SPECIFICATION CHANGES ON THE AT-A2150 AND AT-DSP2200

Due to a component change on revision E or higher of the AT-A2150 board and revision F or higher of the AT-DSP2200 board, the specifications listed below have changed. If you have earlier revisions of these boards, you can disregard this note; the specifications in your user manual are correct.

Figure 1. Input Frequency Response

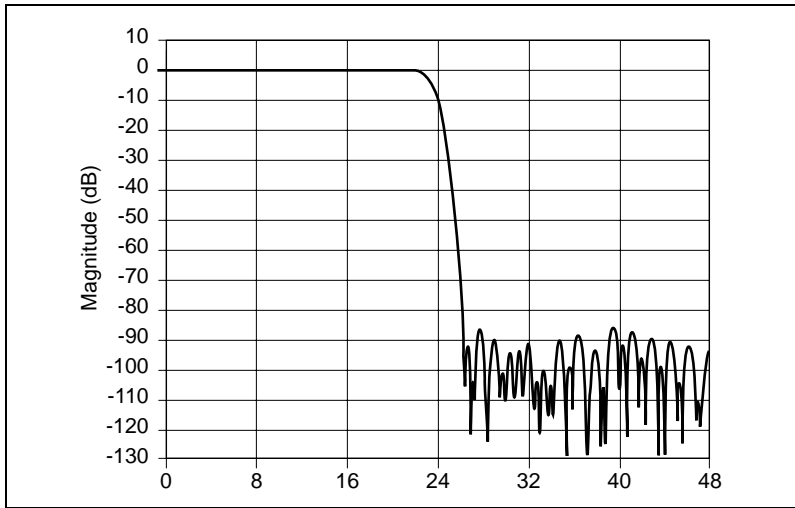
The analog filter cutoff listed on page 3-7 of your user manual has changed from 0.45 times the sample rate to 0.49 times the sample rate. The stopband frequency has changed from 0.5 times the sample rate to 0.542 times the sample rate.

The correct frequency response of the input circuitry is shown in figures 1 and 2. These figures replace figures 3-4 and 3-5 in your user manual.

The response shown in Figure 1 is for a sampling rate of 48 kS/s. For other rates, the x-axis scales proportionally.
